SCUBAPRO®

#274

Engineering Bulletin

MK25 adjustment: minor improvement

Fig. 1

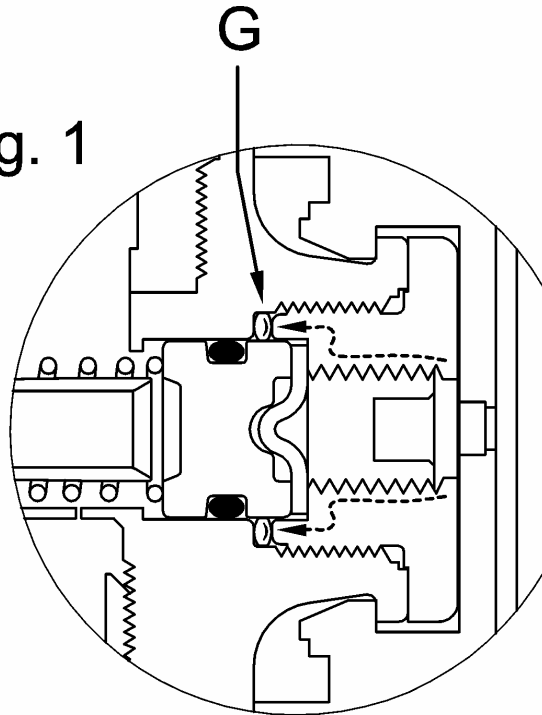
This modification is meant to address the remote possibility of water drops entering through the threads between the seat retainer and the adjustment screw and thus, in the case of the MK25UL only, to form some oxidation (figure 1). For consistency, the change is extended to the entire line. With the new parts, o-ring (O) and washer (W) (fig. 2), the area in question is sealed and dry.

Fig. 2

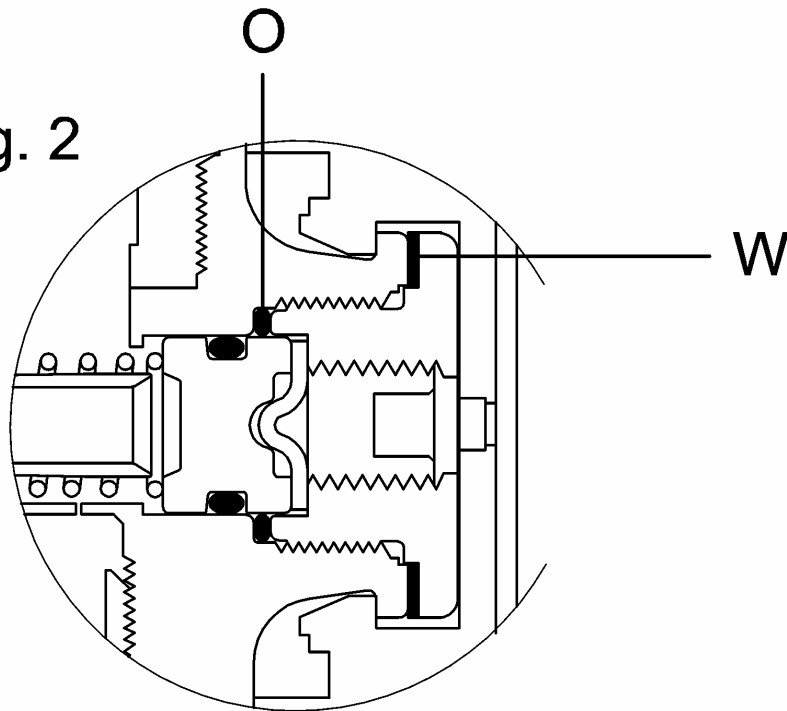
Referring to the drawing below, we have added two parts to the MK25 intermediate adjustment components. The change is now to be found both in the assembled regulators and in the MK25 adjustment kit (PN 41.300.010 and 41.300.020). The parts that were added are:

1 each O-ring P/N 01.050.147

1 each Washer P/N 01.060.220

Important : only one washer (the thicker one) has to be placed under the seat retainer (to compensate for the thickness of the new o-ring).
